PIC16C774 Rev. B Silicon Errata Sheet

The PIC16C774 (Rev. B) parts you have received conform functionally to the Device Data Sheet (DS30275A), except for the anomalies described below.

In the Device Data Sheet (DS30275A), the following clarifications and corrections should be noted.

FIGURE 15-1: PIC16C773/774 VOLTAGE-FREQUENCY GRAPH, $-40^{\circ}\text{C} \leq T_A \leq +85^{\circ}\text{C}$

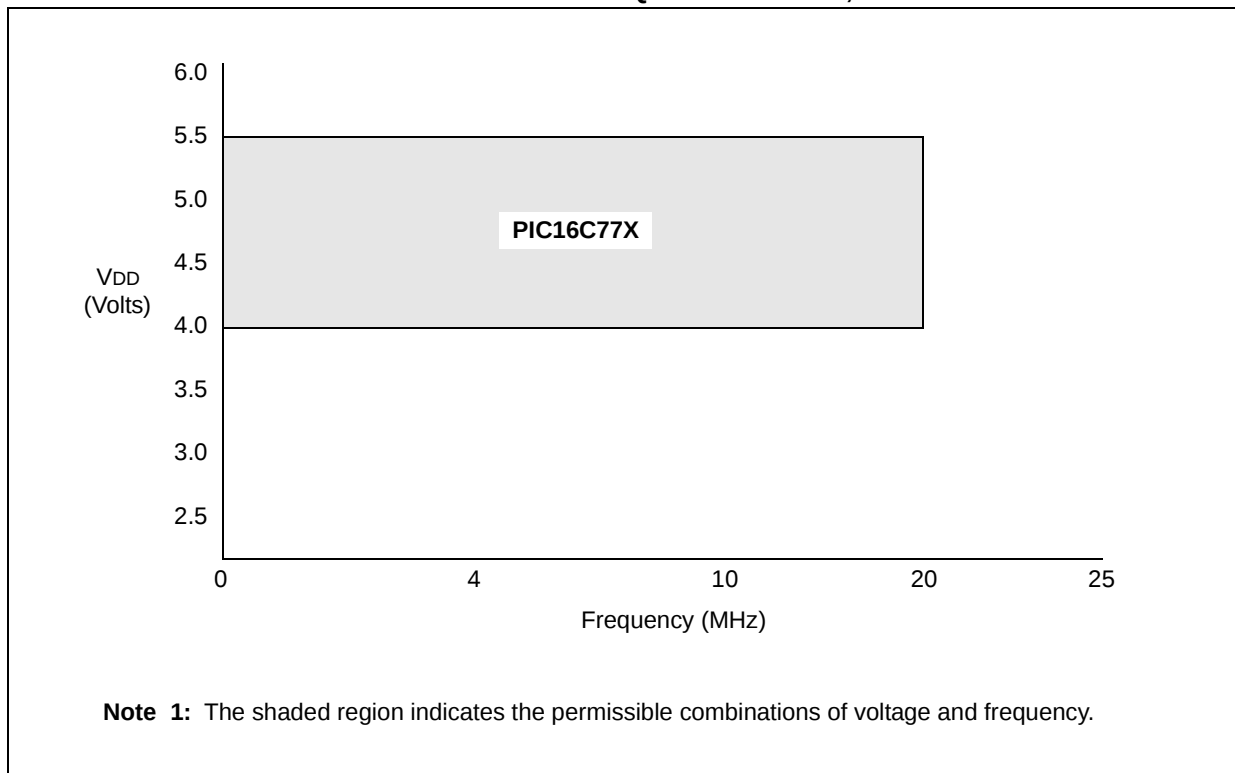
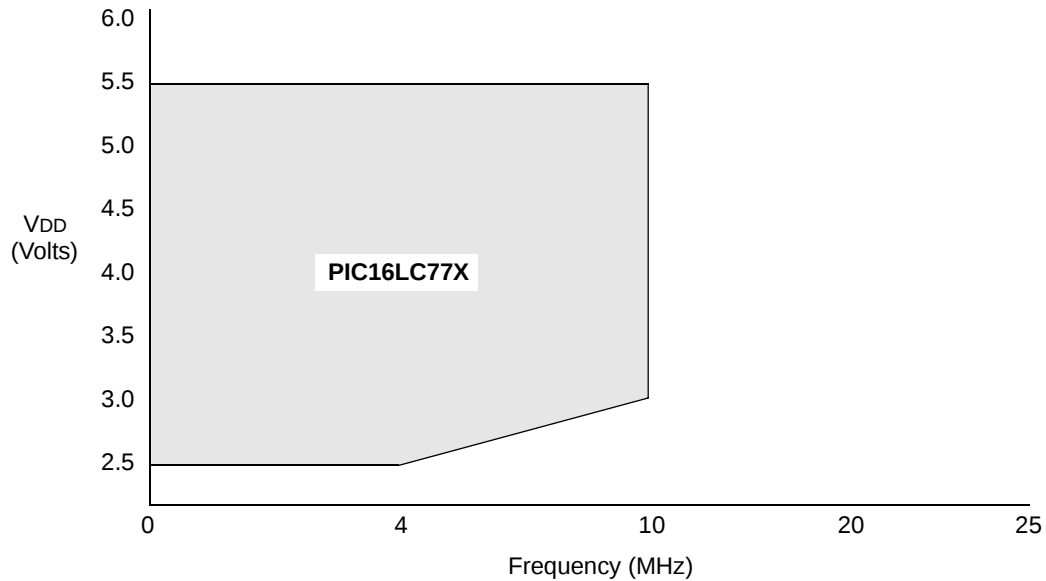
1. Table 15-1 in the Device Data Sheet (DS30275A) should be omitted. Figure 15-1 and Figure 15-2 below should be used to determine the operating voltages and frequencies for the devices.

$$F_{\text{MAX}} = (12.0 \text{ MHz/V}) (V_{\text{DDAPP MIN}} - 2.5\text{V}) + 4 \text{ MHz}$$

- Note 1:** VDDAPPMIN is the minimum voltage of the PICmicro® device in the application.
- 2:** FMAX has a maximum frequency of 10 MHz.
- 3:** The shaded region indicates the permissible combinations of voltage and frequency.

FIGURE 1: A/D CLOCK SOURCE BLOCK DIAGRAM

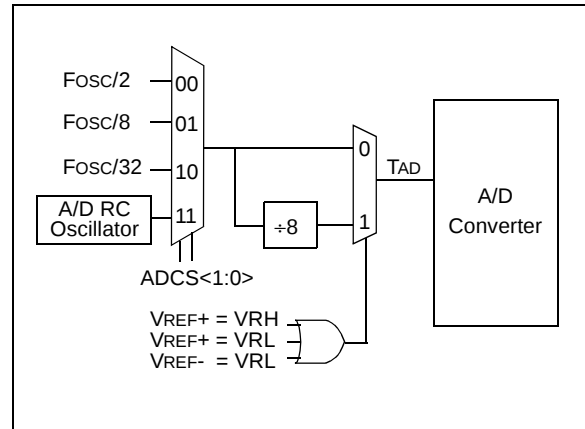
8. The A/D clock source bits (ADCS1:ADCS0) have had their operation modified. See Register 1 for a new definition of the ADCS1 and ADCS0 bits.

Figure 1 shows how the TAD time is determined based upon the selection of the ADCS<1:0> bits and the source of VREF+ and VREF-. When VREF+ or VREF- comes from the internal voltage reference (VRH or VRL), then the required TAD time is increased by a factor of eight (see electrical specification parameter #130A).

The clock source selected by the ADCS<1:0> bits is divided by eight when an internally generated reference voltage is used as reference to the A/D module. This automatically addresses the requirement for the TAD time, when the internal voltage reference is used as the A/D voltage reference.
